SUBJECT: Response to NRC Request for Additional Information Regarding TSTF-478, Revision 0, "BWR Technical Specification Changes that Implement the Revised Rule for Combustible Gas Control," dated November 9, 2006

**Response to NRC Request for Additional Information Regarding
TSTF-478, Revision 0, "BWR Technical Specification Changes that Implement the Revised
Rule for Combustible Gas Control," dated November 9, 2006**

The following are the Technical Specification Task Force (TSTF) responses to the NRC's November 9, 2006, Request for Additional Information (RAI) on TSTF-478, Revision 0.

Figure 1

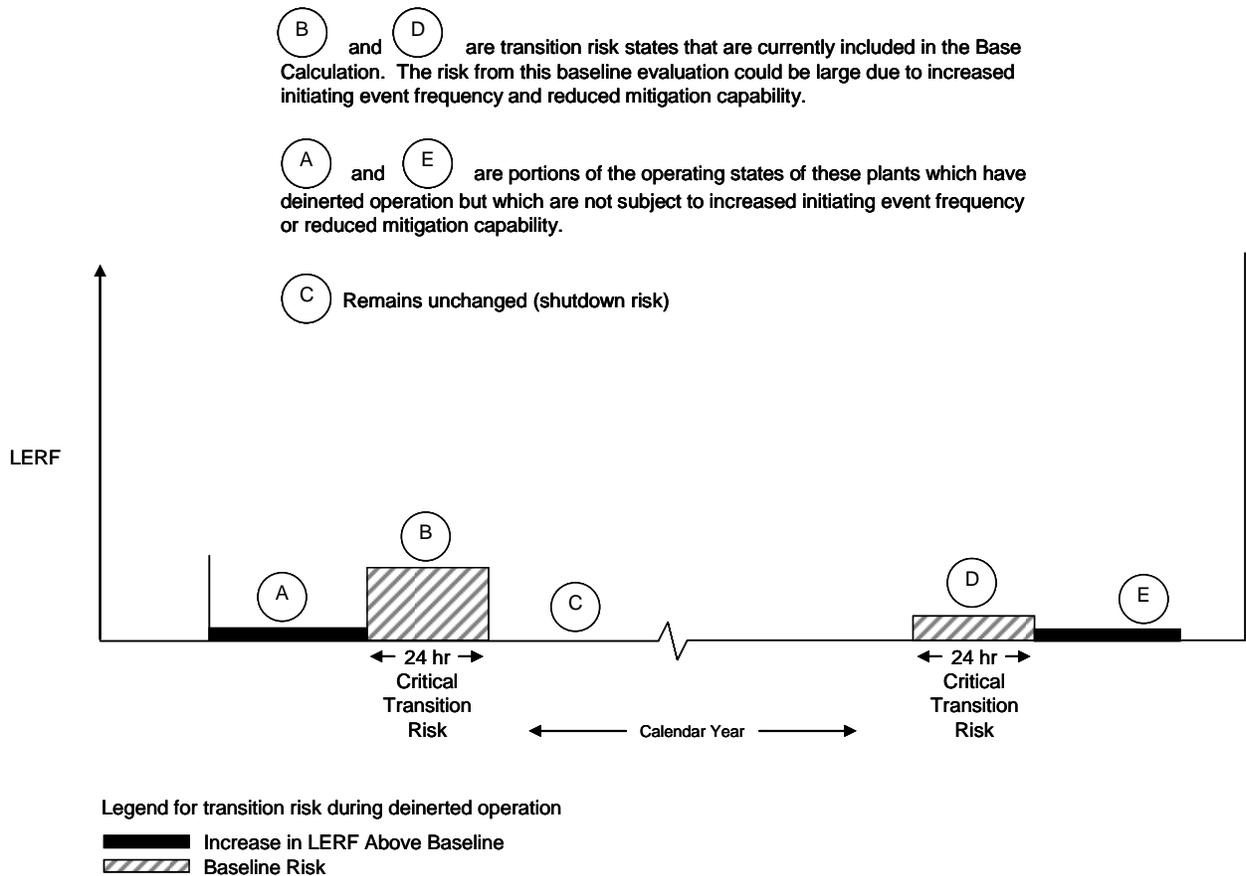
2. *Based on a scoping assessment performed by the NRC staff, the Δ LERF for the proposed extension would exceed the $1E-7$ per year value associated with a "very small change" in RG 1.174. Provide an assessment of the approximate level of the risk increase associated with extending the completion time from 24 hours to 72 hours. This assessment should address the factors identified below.*

Figure 1, below, illustrates that while the duration of the time the containment is not inerted increases, which may influence the Δ LERF calculation, that the transition risk remains concentrated within a 24 hour period and that there is essentially no change in the transition risk between the two conditions, baseline (24 hours allowed de-inerted) and proposed change (72 hours de-inerted).

ATTACHMENT A

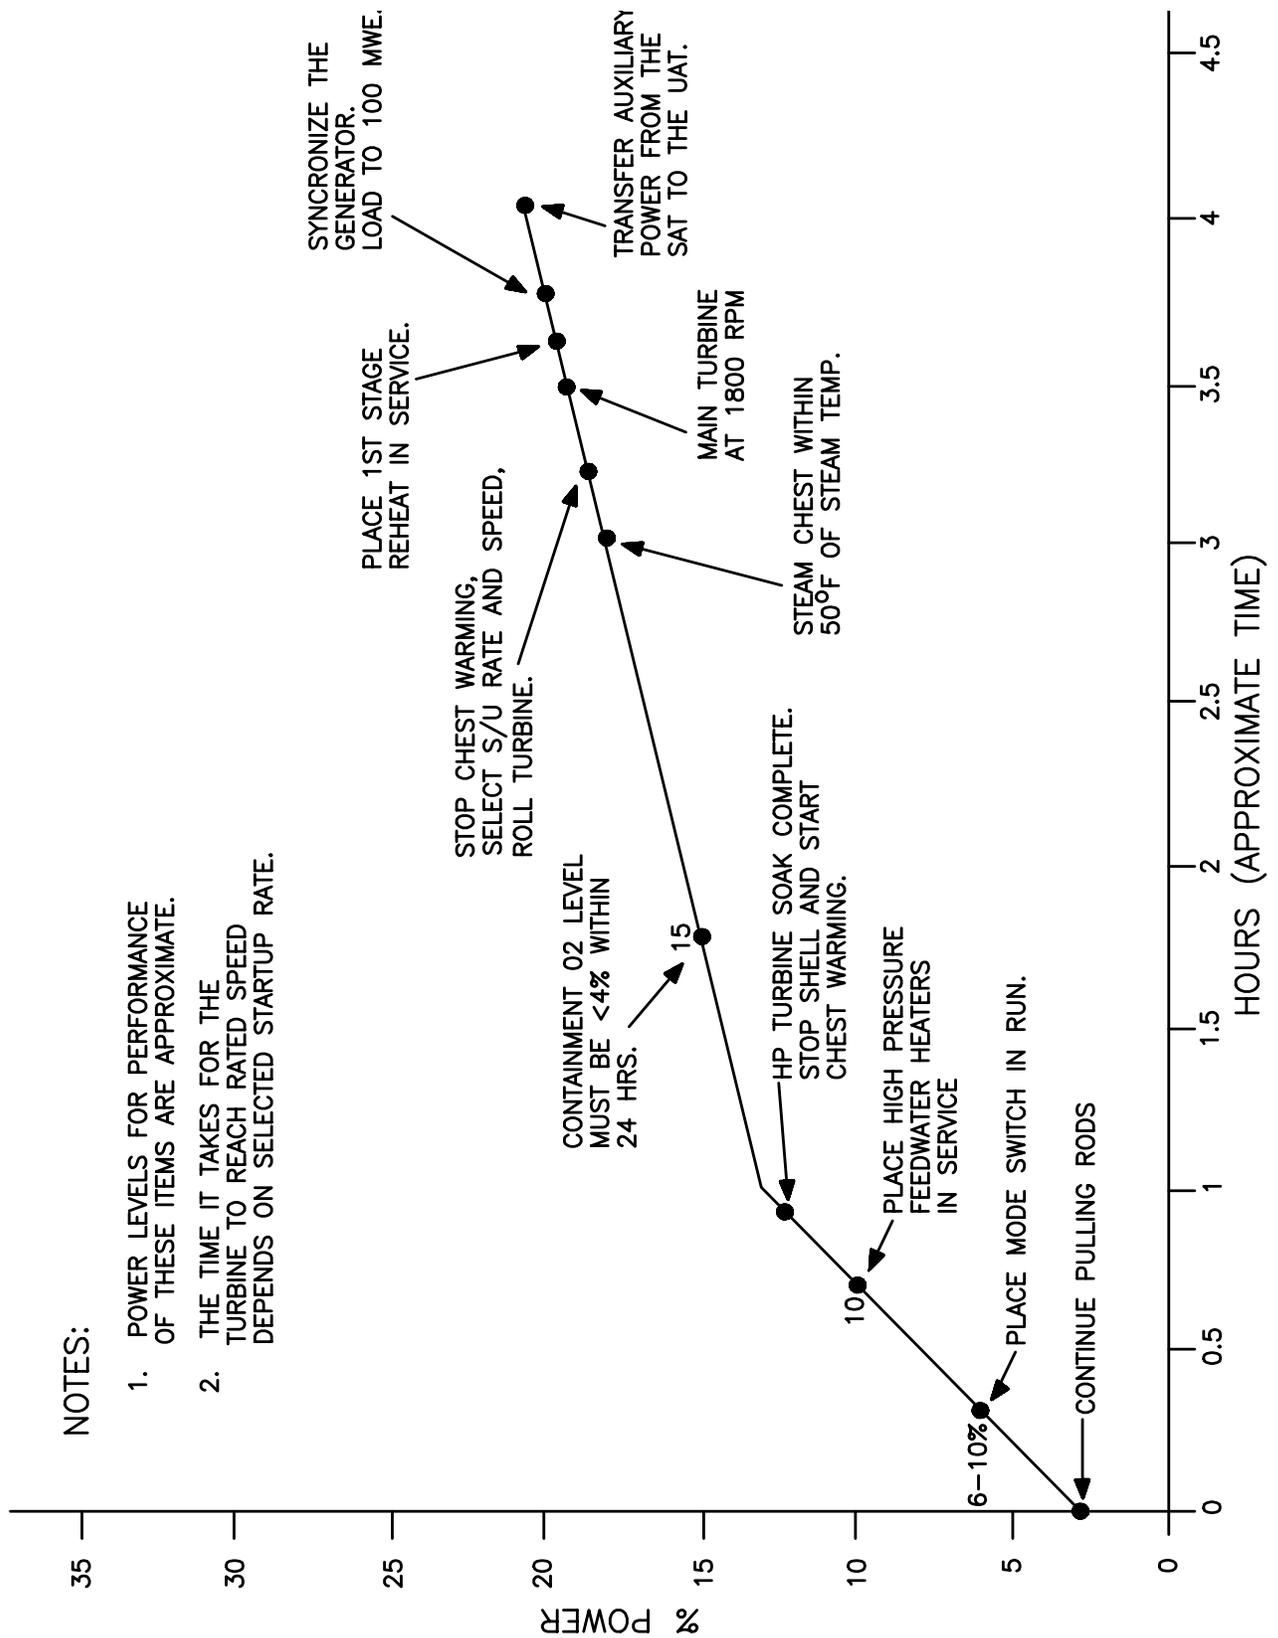
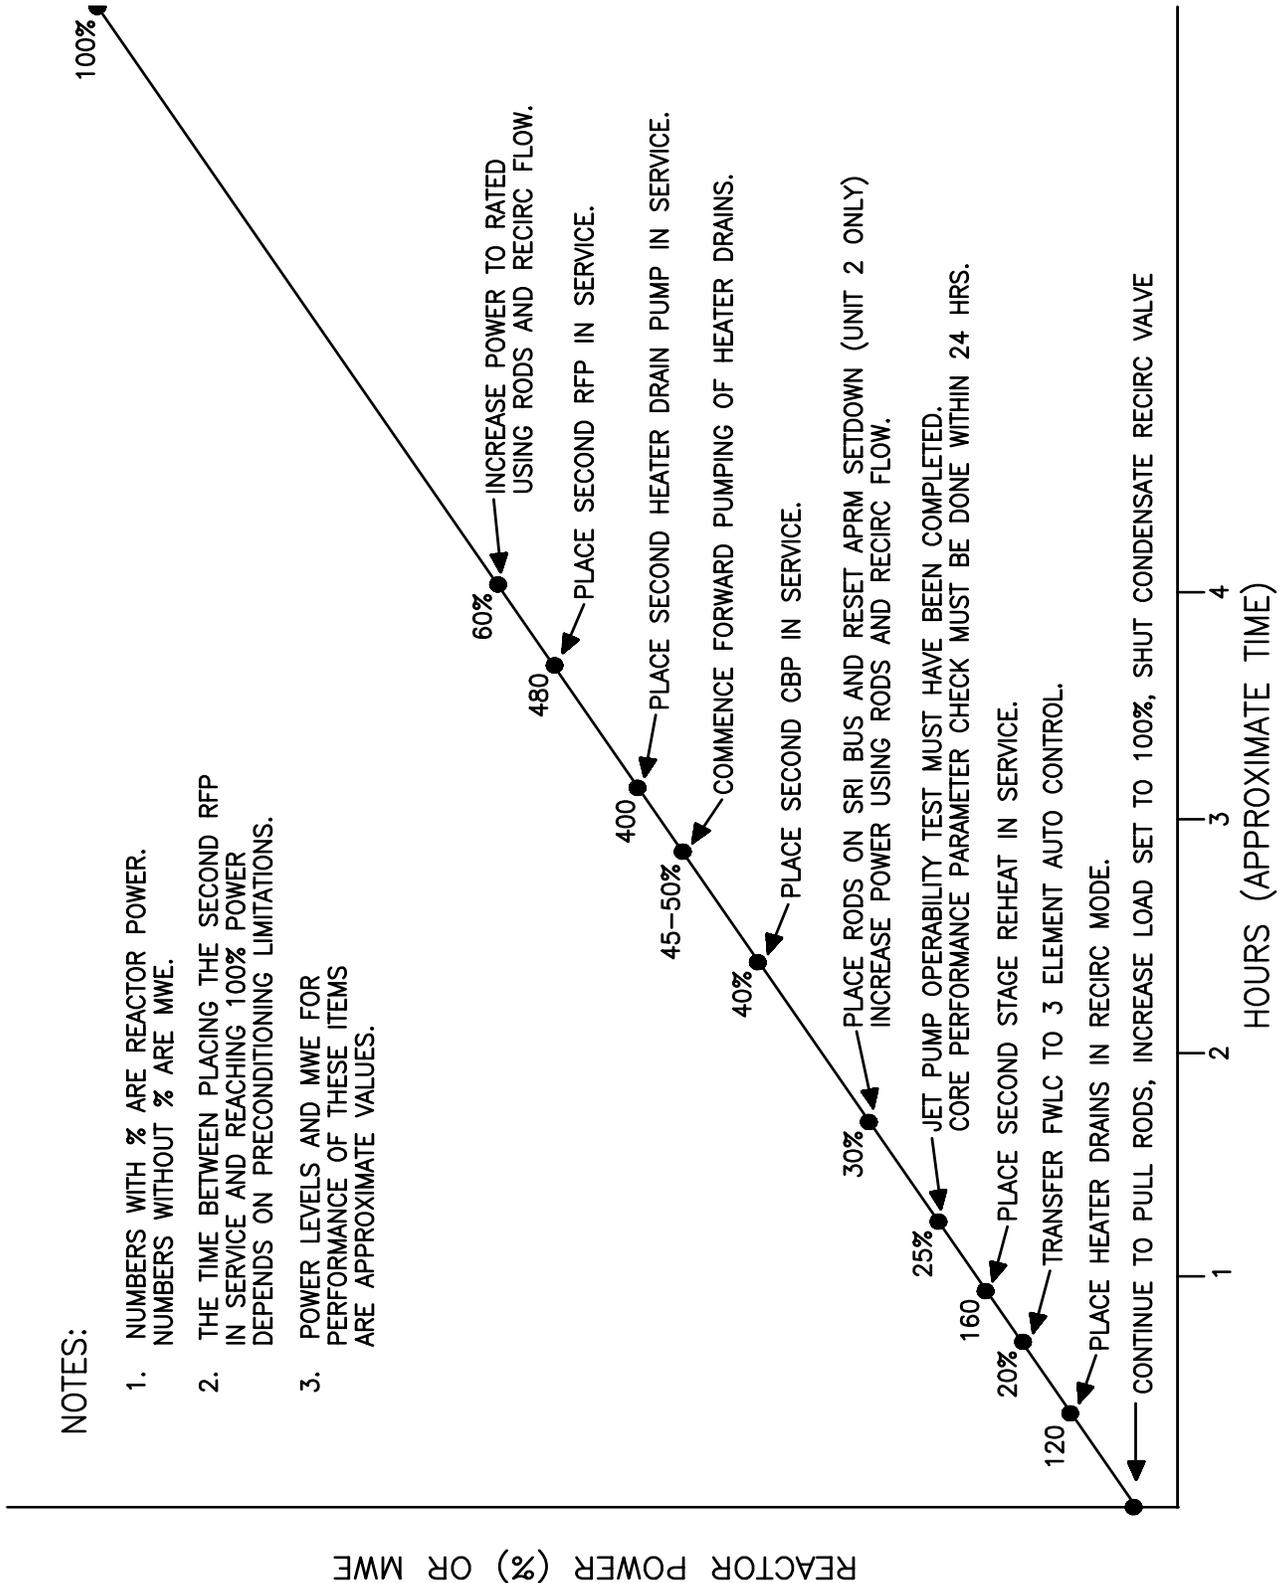
1. *Provide the following information to better understand the rationale and benefits associated with extending the period of deinerted operation from 24 hours to 72 hours:*

Attachment A depicts a generic startup timeline highlighting key events. It is used for training purposes at some plants and reflects the anticipated sequence of events if problems are not encountered. Attachment A does not include all testing and Surveillance Requirements that may be required during plant startup. For example, control rod drive scram time testing is not included but is a time-consuming test performed at 20-40% power. Scram time testing can identify system problems that may require containment entry. The existing 24 hour limit for inerting containment begins when the plant exceeds 15% power. Note that above 60% power, full power operation is achieved using control rod withdrawal and reactor recirculation flow increases, and no additional systems are placed in service or Surveillance Requirements required in order for the plant to achieve full power operation.

Attachment A indicates approximately 7 hours is needed to raise power from 15% to 60%. However, balance of plant problems often extend this time. The time to perform the steps necessary to inert the containment vary depending on the size of the containment and inerting system capabilities, but can be completed within 4 to 6 hours with an experienced plant staff and assuming no problems are encountered with the inerting equipment. Thus, it can be expected that if containment inerting is started at 60% power, it would be completed within the existing 24 hour limit. The proposed 72 hour limit to inert containment is requested to provide time to respond to unexpected problems during startup.
